**Final RFI/RI Report Burma Road Rubble Pit (231-4F)**

**FINAL  
RFI/RI REPORT  
BURMA ROAD RUBBLE PIT (231-4F) (U)  
VOLUME I**

**DOCUMENT APPROVAL SUMMARY**  
**RCRA FACILITY INVESTIGATION/REMEDIAL INVESTIGATION**  
**REPORT FOR**  
**THE BURMA ROAD RUBBLE PIT (231-4F)**

Figure 1-3 - Burma Road Rubble Pit.

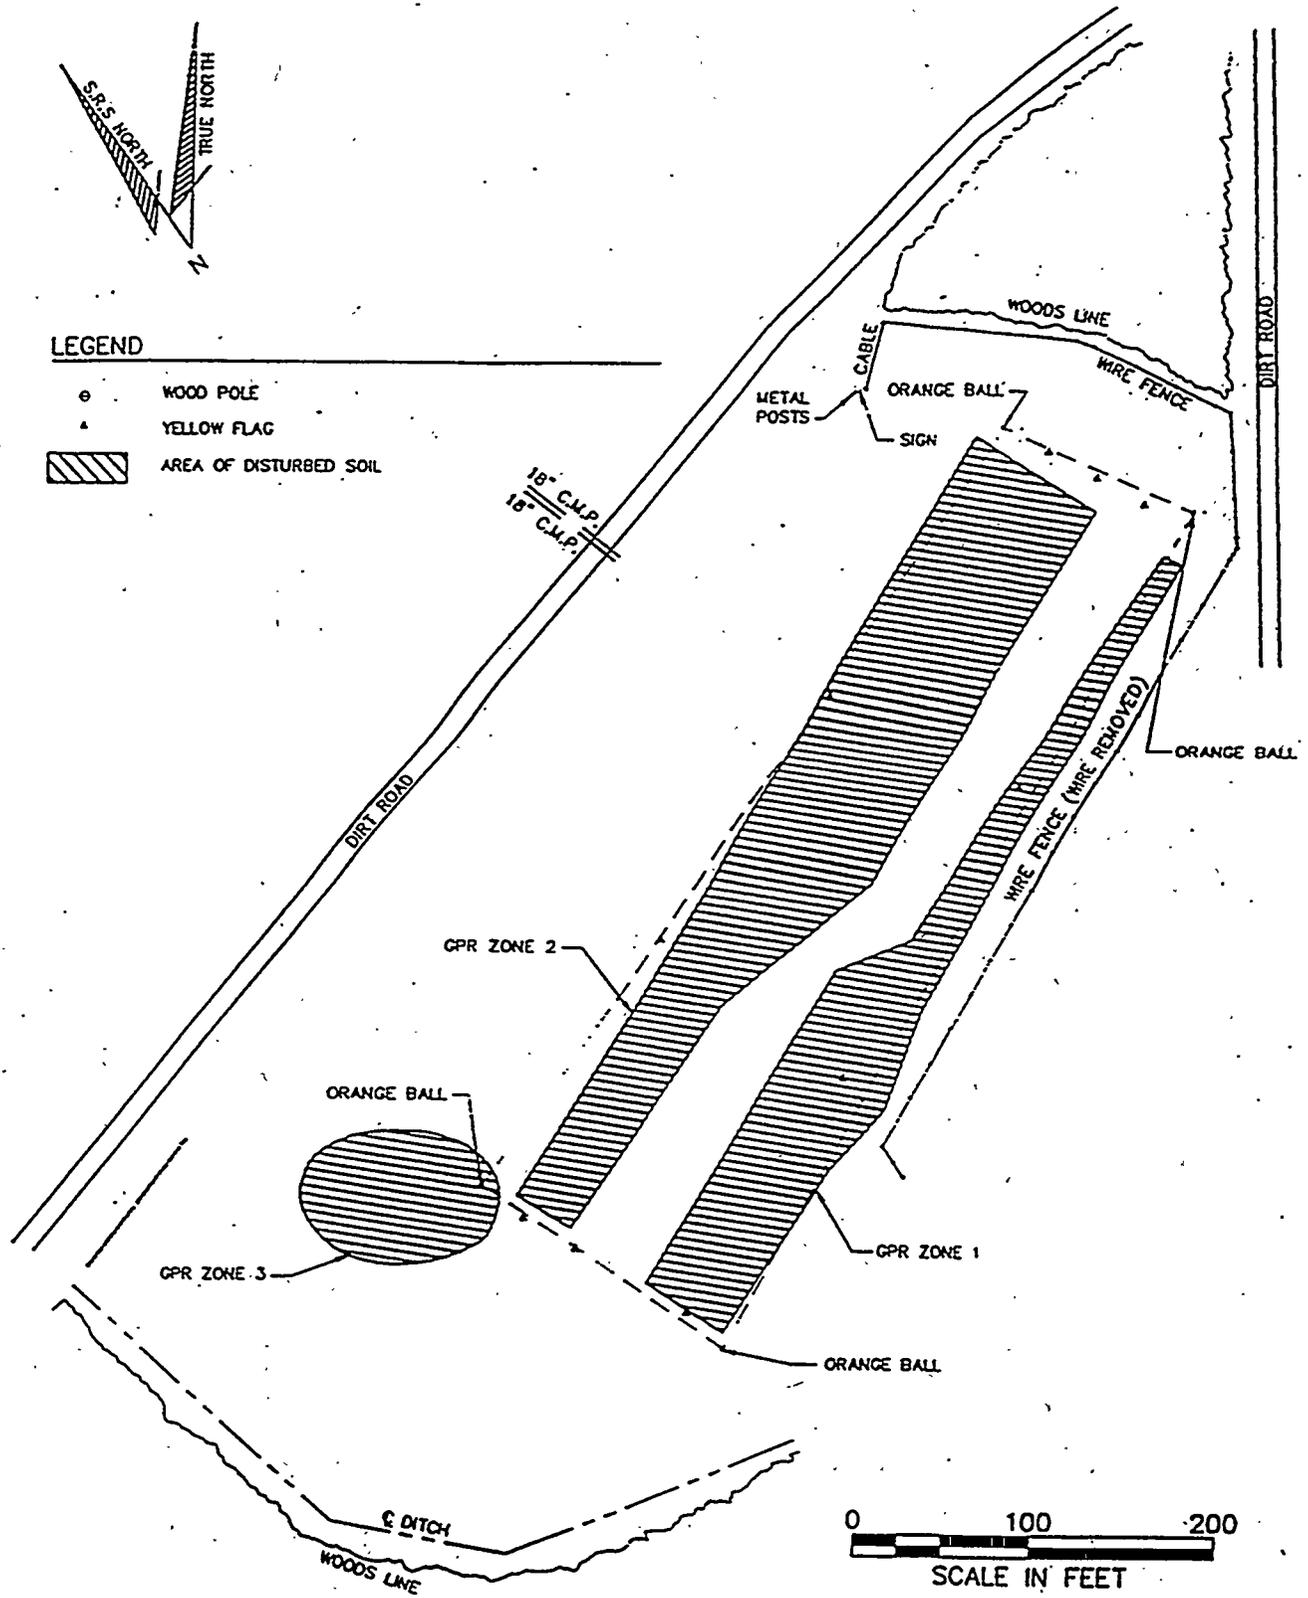
8. pg 3-17, Paragraph 3, Sentence 4: One of the Surface and Subsurface Soil Sampling Objectives was to determine contamination within GPR Zone 1, 2, and 3; however, the text does not define the zones within the context of this section. The text should identify the GPR zones or refer the reader to Figure 1-3.

AGREE. Page 3-17 has been amended to refer the reader to Figure 1-3.
